I have reviewed and highlighted concerns in the following areas:

Written Representation from Diane Abbott

Image from Landscape and Visual Figures 5.10k (Year 1). With field measurements.

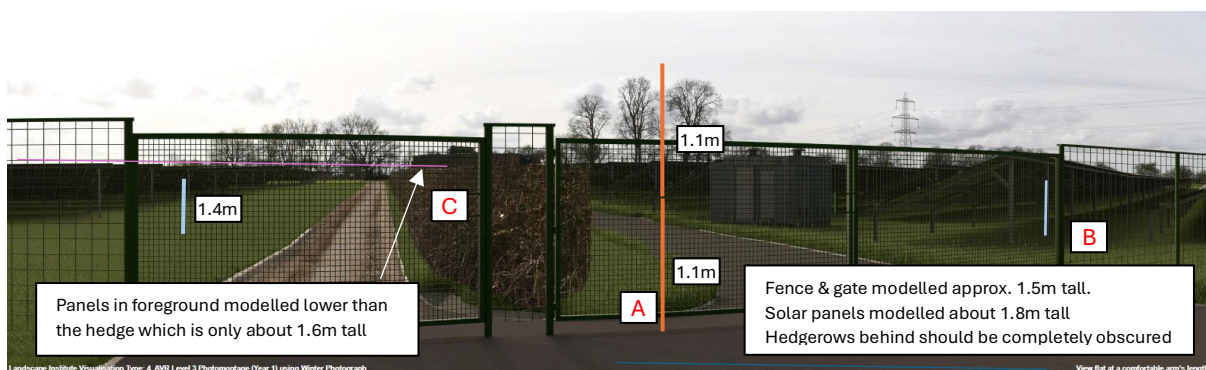
In the next image, it can be seen that:

A: The stacked orange lines suggest that the security fence is modelled as significantly less than 2.2m tall, perhaps 1.5m tall. In reality the fence would almost meet the top of the orange bar and would obscure the distant trees.

B: I have mirrored the 1.4m tall blue line over to the right of the image, keeping it at the same distance from the centre of the photograph so that it is effectively the same distance from the camera as the original measurement. From this comparison, it can be seen that the solar panels here are modelled as not much taller than 1.4m, perhaps 1.8m (instead of 2.7m).

C: The winter height of the hedge at point C is approximately 1.6m. (See comparison with the gatepost and gate). Using the horizontal pink line we can see that the solar panels on the left of the image have been modelled as being lower than the hedge. In reality they should be about 1m taller, which would again obscure the distant trees.

Overall the view from this location would be entirely industrial, with only the tips of the distant trees appearing above the solar panels and fences.

Zoomed in image showing increased height of solar panels if they had been modeled based on ground topography.

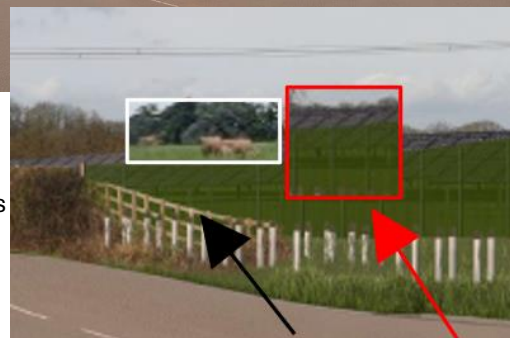
In the image below, I have taken a recent photograph showing cows in the field, and overlaid onto the winter image so that the topography becomes clear. The cows are not behind the hedge as you might expect, but are on the horizon because of the rising hillside.

Image from Landscape and Visual Figures 5.11c (Year 1)

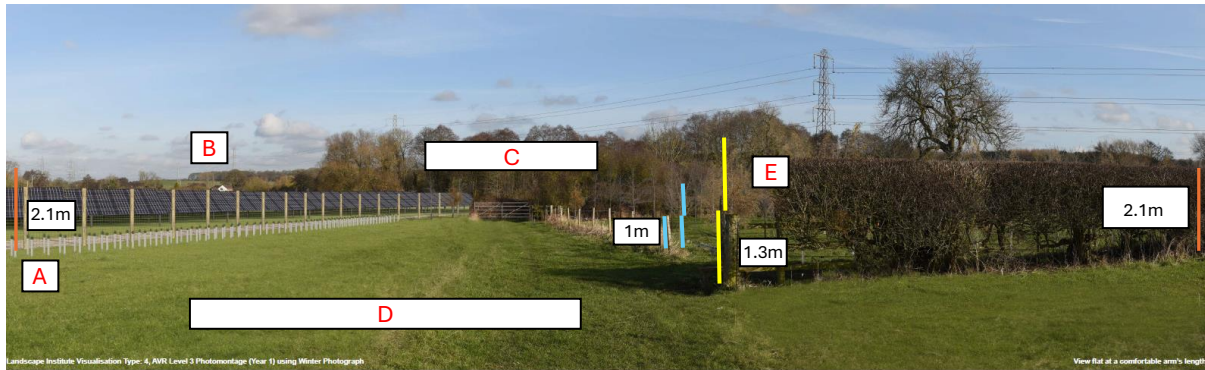
The Year 1 visualisation is shown below, together with measured heights of defined objects. Note that this image contains significant tree planting on the right of the image in the field behind the hedge, although it is hard to see without zooming in.

This view has been used as the cover image for much of the Oakland's Solar literature as it shows a discrete solar farm nestled into the surroundings. This is not accurate.

A: Mirroring the orange line to the other side of the photo, it is possible to see that both the fence and solar panels have been modelled at a height that is much lower than 2.1m. In reality the fence should be as tall as the orange line. The tops of the solar panels, being close to the fence (but far from the observer) should rise above the fence.

E: Newly planted trees are shown as almost 2.6m tall, with good canopies. In the first year, these are more likely to be 1m saplings virtually enclosed by their tree protectors. This mitigation planting height exaggeration is continued in the Year 10 images (not shown here).
